**PROPOSED TECHNICAL SPECIFICATION CHANGES
POWER UPRATE**

(JPTS-91-025)

JAMES A. FITZPATRICK NUCLEAR POWER PLANT

Docket No. 50-333

1. Page 134, Figure 3.5-1 - Thermal Power and Core Flow Limits

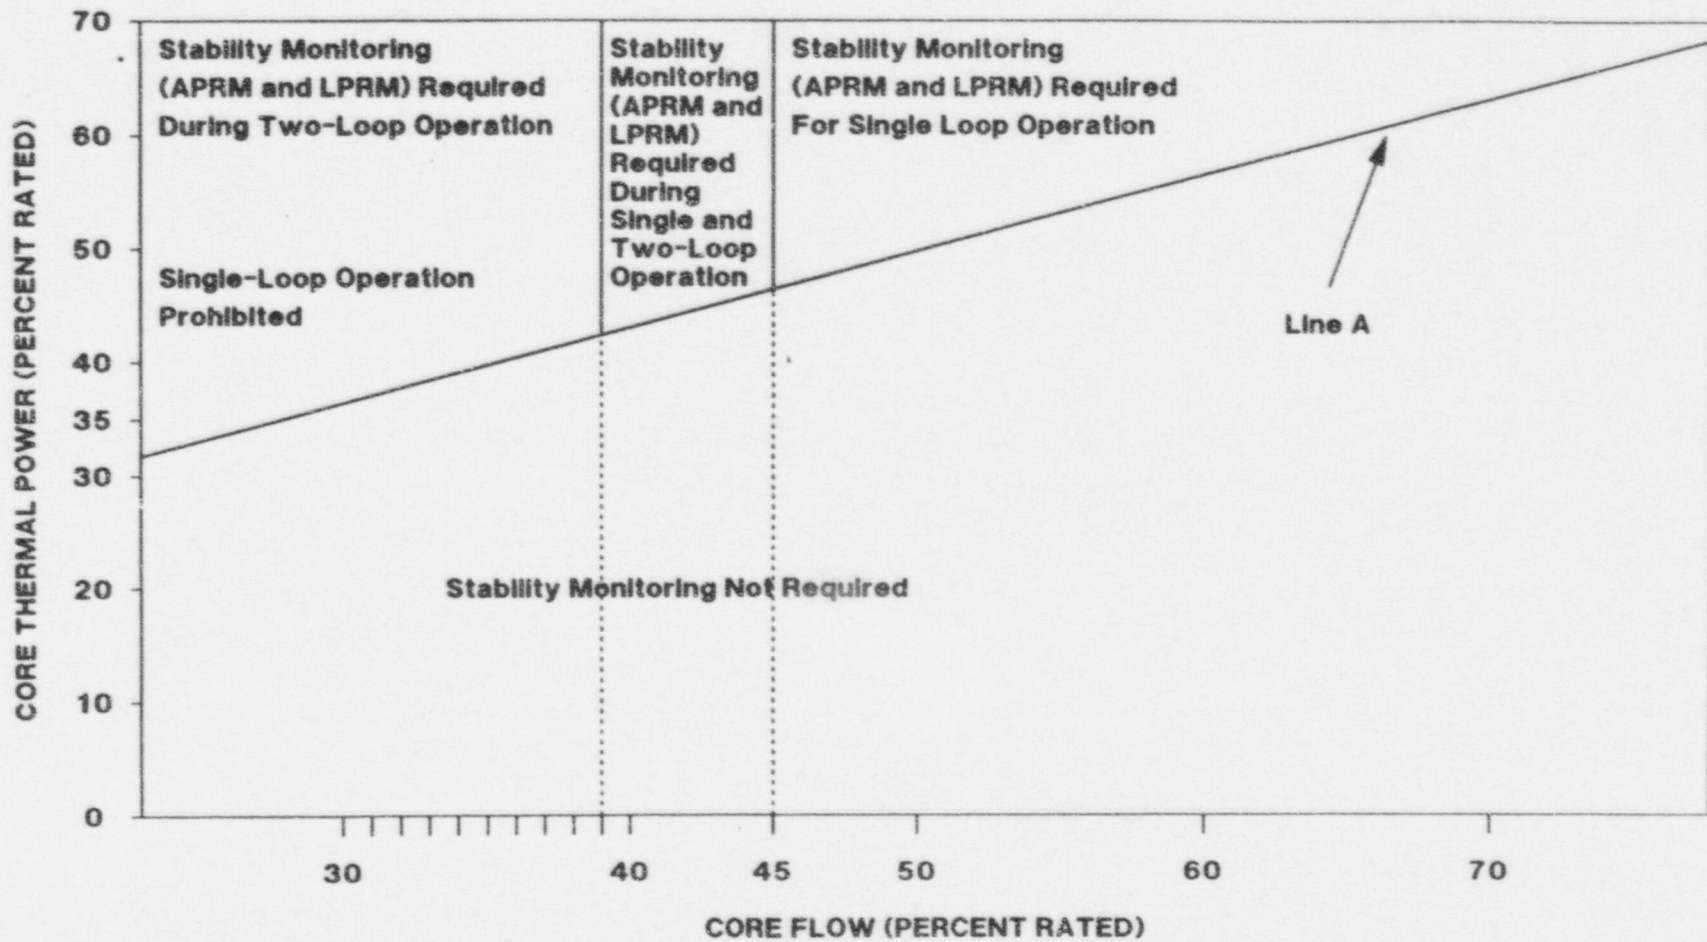
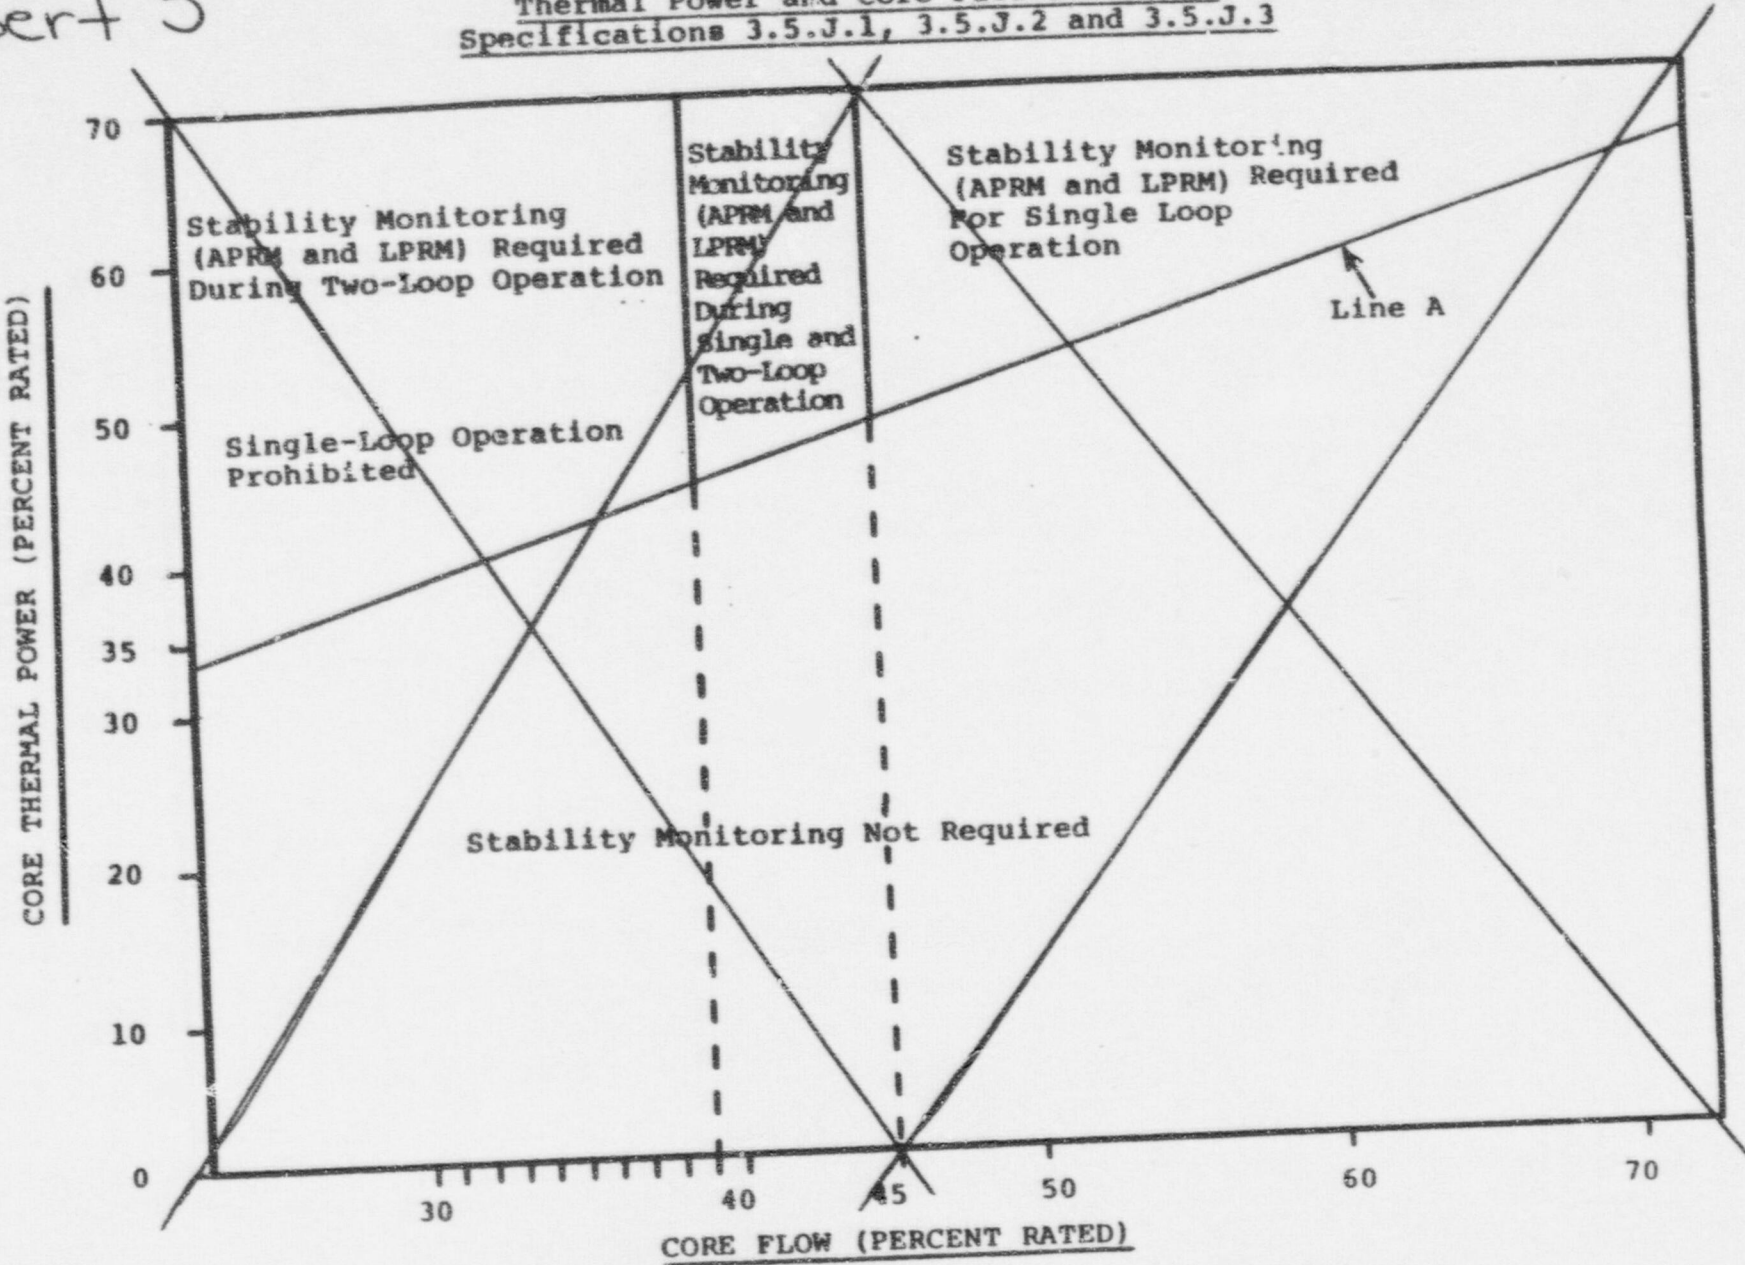
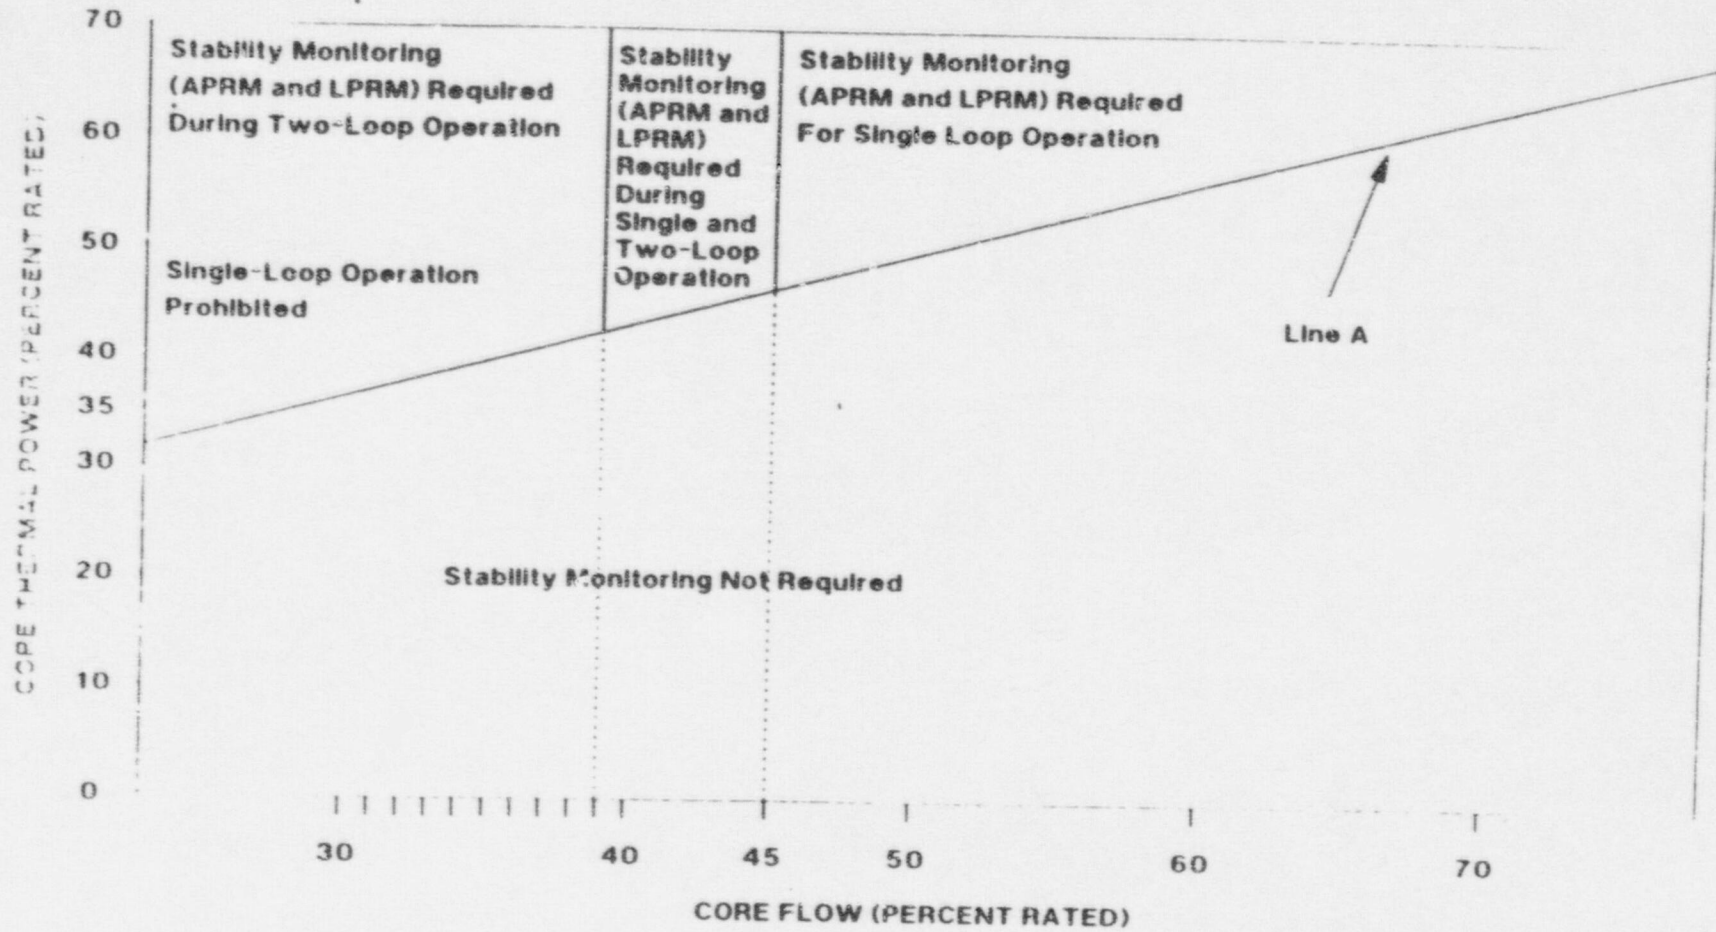
Replace the existing Figure 3.5-1 with the revised Figure 3.5-1.

Revise the core thermal power versus core flow operating map for operation at uprated power.

Uprated power will shift the line of core thermal power versus core flow which is used to control thermal hydraulic stability. The core thermal power value at which stability monitoring is not required is reduced by 0.96% at each core flow value on Figure 3.5-1. This reduction is in proportion to the ratio of rated power (2436 MWt) to uprated power (2536 MWt). This change assures that the relationship between thermal power and flow represented by "Line A" on Figure 3.5-1 will not change. Therefore, the thermal power cutoff point used, at various flows, to prevent single loop operation or to require stability monitoring for single and two loop operation remains the same. With no change to these values, the margin of safety remains unchanged. The safety implications have been generically evaluated in Section 3.2 of LTR-2, as noted in Section 2.4 of the PUSAR.
